# MEMO

**To:** Megan Norwood, City Planner II, City of Auburn  
**From:** Sean Thies, P.E., Senior Project Manager, CES, Inc. (CES)  
**Re:** BD Solar Auburn, LLC | Development Review Application  
**Date:** March 5, 2020

CES has prepared this Memo in response to requests from the City of Auburn Planning Department for BD Solar Auburn, LLC's Development Review Application. The requirements are written in italics, followed by CES' response.

| DRAWING NUMBER | C101       |

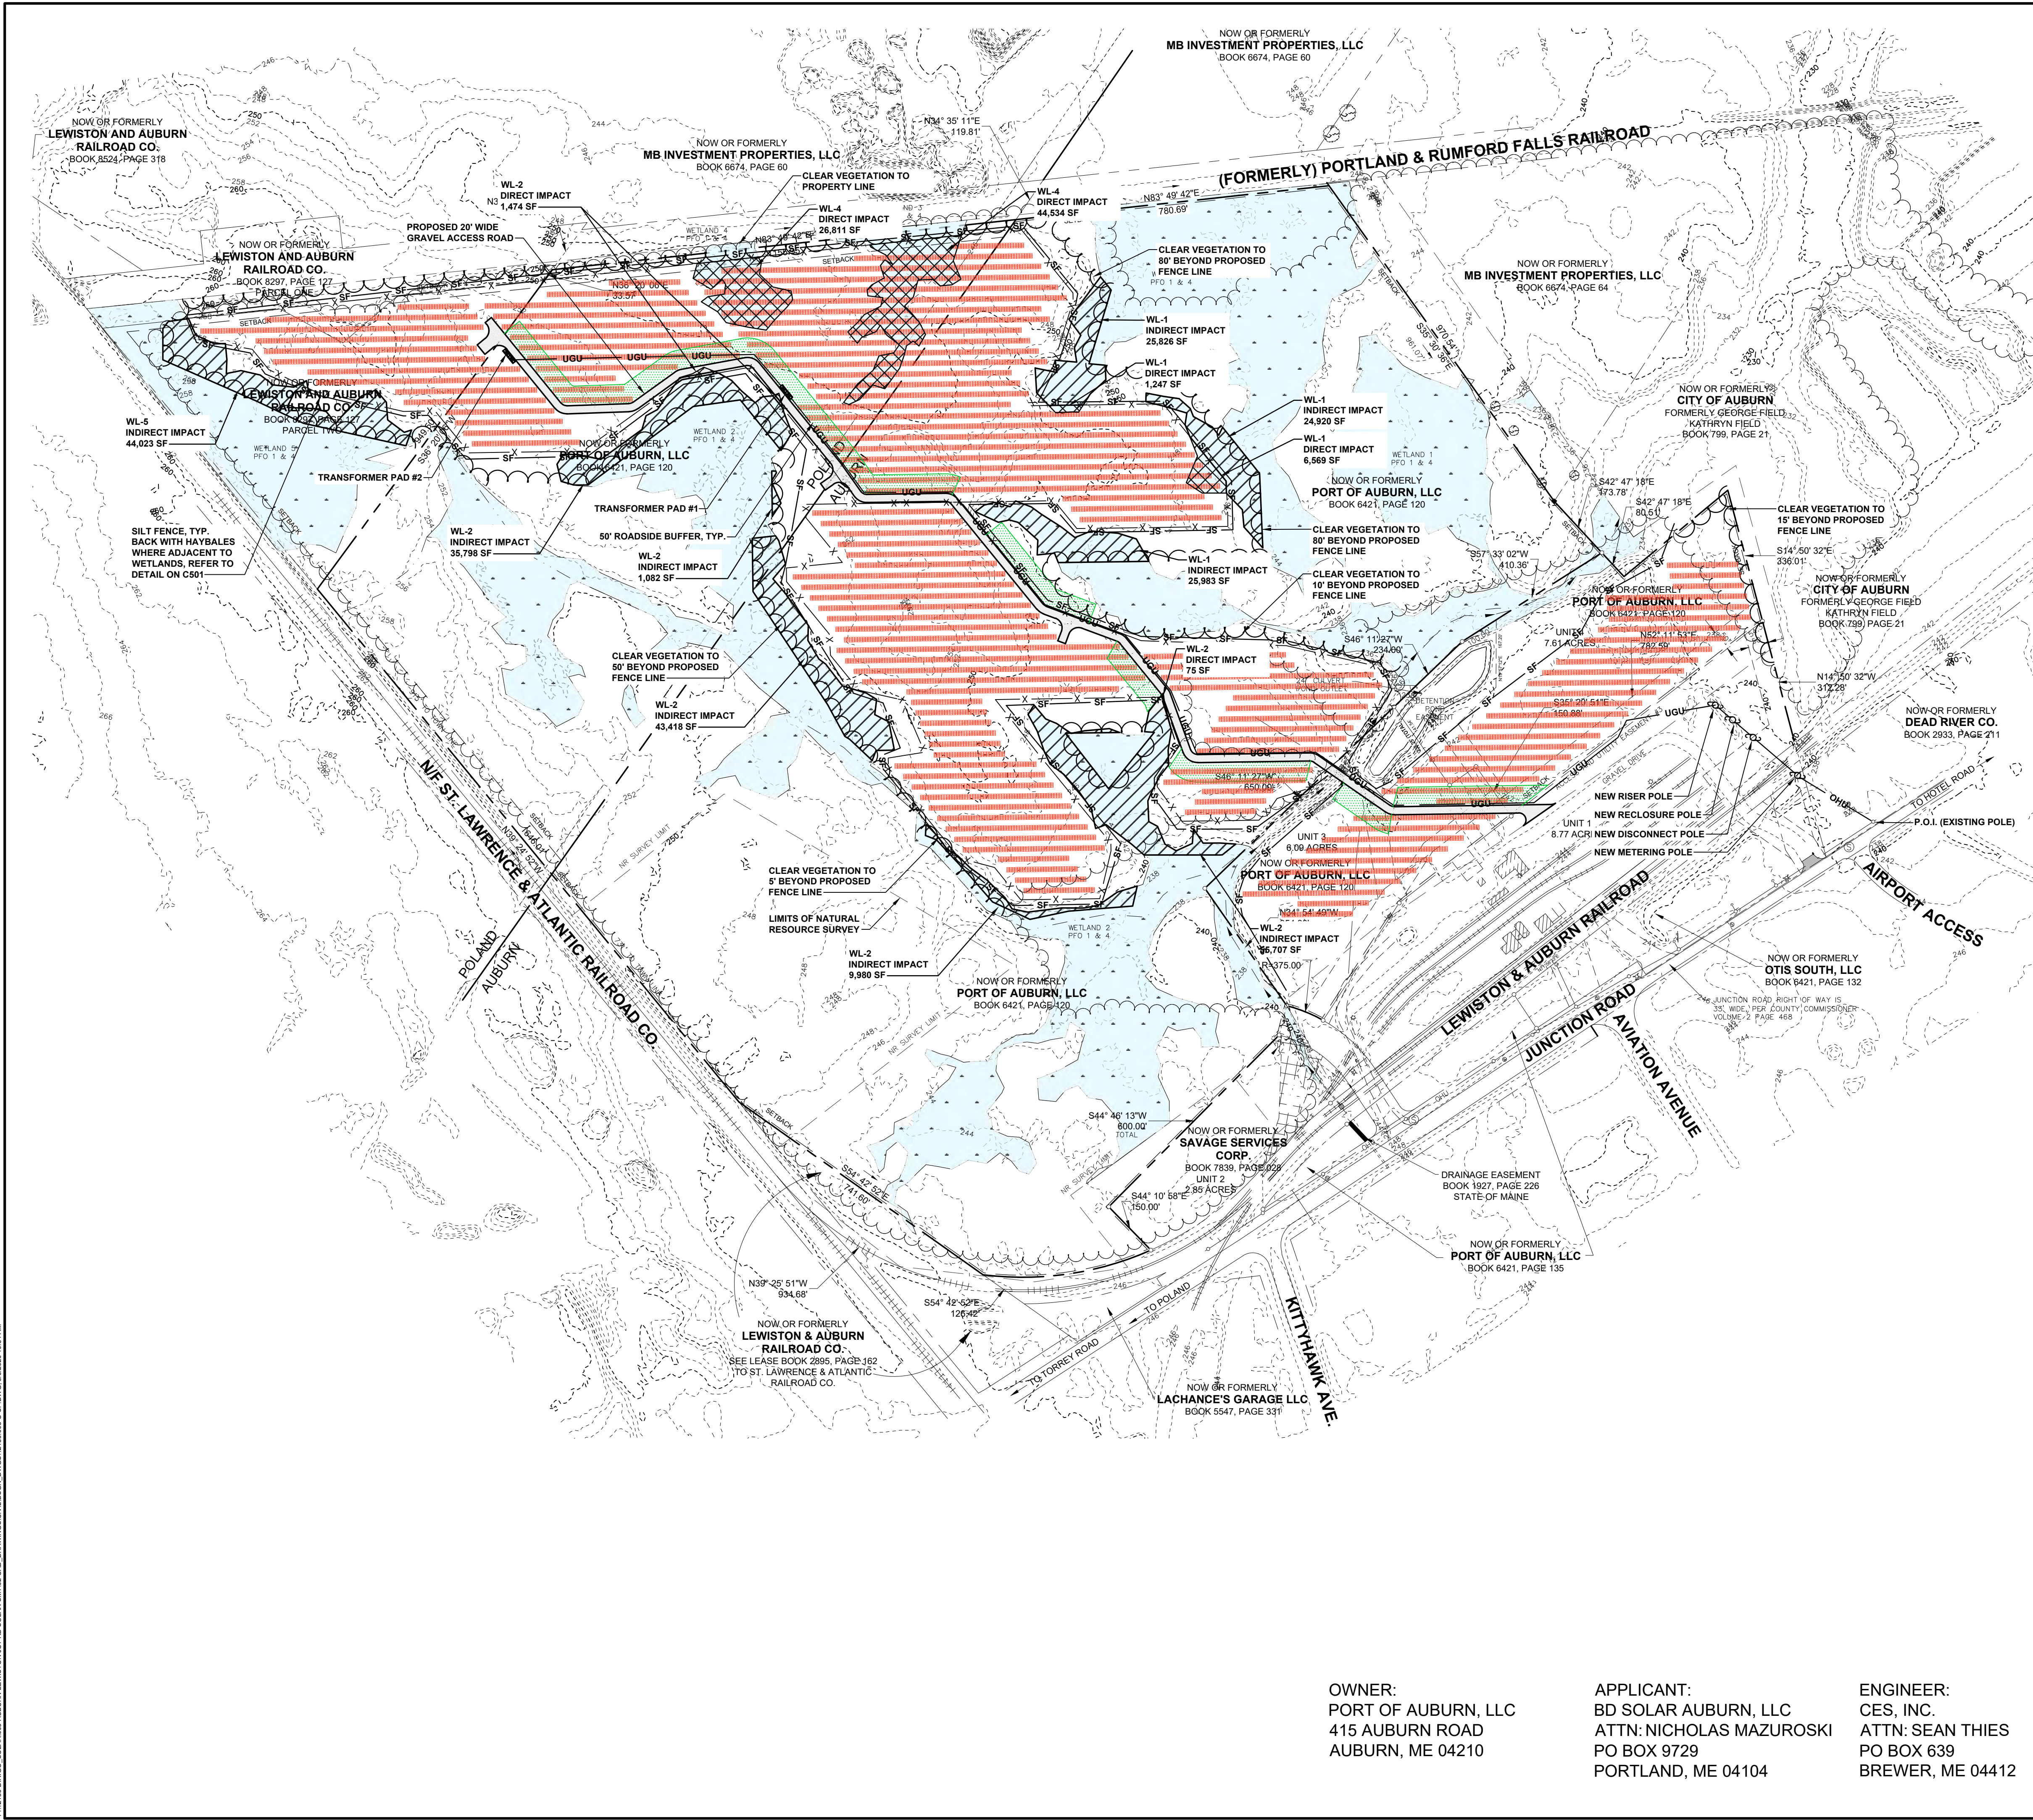
2. Do you have the redesign of the width of the access road and addition of turnarounds? The Engineering Department is waiting for that information before issuing their signoff on the project because they say it will completely change the stormwater calculations.
- a. On the same note, could you highlight where the access drives are located on the site? Based on the plan, it appears you have one proposed where the underground utilities are located. Are there any other small access roads to access the panels in an emergency or how would that work? It also isn't clear to us where the access road itself will be accessed from. Will access be through another parcel off of Lewiston Junction Road?

5. *The Industrial District has specific landscaping standards between nonresidential uses (Evergreen tree line planted in staggered rows having the base of the trees not more than 10 feet apart. The width of the screened buffer line shall not be less than 15 feet). It appears some of the panels are located in close proximity to the property line. A buffer such as this may be prohibitive to the solar project due to shading, etc. Could you provide a response to those landscaping standards that we could provide to the Planning Board? The Planning Board will likely ask for a waiver request to be submitted and justification for the waiver. For reference the Ordinance section is: Sec. 60-579(3)(g)(4).*

(3) An accurate scaled site plan of the subject property showing the planned location of the proposed Solar Energy Generating System and all associated facilities; property lines, adjoining streets and access; topographic contour lines; existing and proposed buildings; fencing; structures; **potential shade from nearby trees and structures;** vegetation; driveways, parking and curb cuts on the subject property; **specifications for all proposed electrical cabling/transmission lines, accessor equipment and landscaping, including the tallest finished height of the solar collectors and name,** address, phone number and signature of the project proponent, as well as co-proponents or property owners, if any, the names, contact information and signature of any agents representing the project proponent. The site plan shall show **any proposed off-site modifications to provide grid connections,** access the installation, or to maintain the proposed solar energy system.

Please refer to the attached Site Plan, revised. The stormwater calculations were previously performed assuming a 24-foot wide road, which exceeds the design road width of 20-feet. The calculations have been revised, reducing impervious areas to reflect the 20-foot wide road and increasing areas for the three new turnarounds. Impervious areas decreased by 3,134 Sf, 2,390 SF and 2,130 SF for sub-catchments 1, 2 and 3, respectively. The existing impervious area not previously accounted for in sub-catchment 1 was also added to pre-development conditions. The following table summarizes the revised pre- and post-development stormwater runoff. The stormwater runoff results in the table below show that the estimated runoff has not changed from the original submission.

The proposed tree-line has been revised in the southeast property corner to maintain existing woodland within 15-feet of the property line.

Please refer to the revised Site Plan showing the proposed tree-line. Although shading of the panel will be avoided along the majority of the project, some shading from vegetation may occur to meet City landscaping standards. The grid interconnection is also shown on **C-101 Site Plan**. Please refer to the attached technical data for information on accessory equipment.
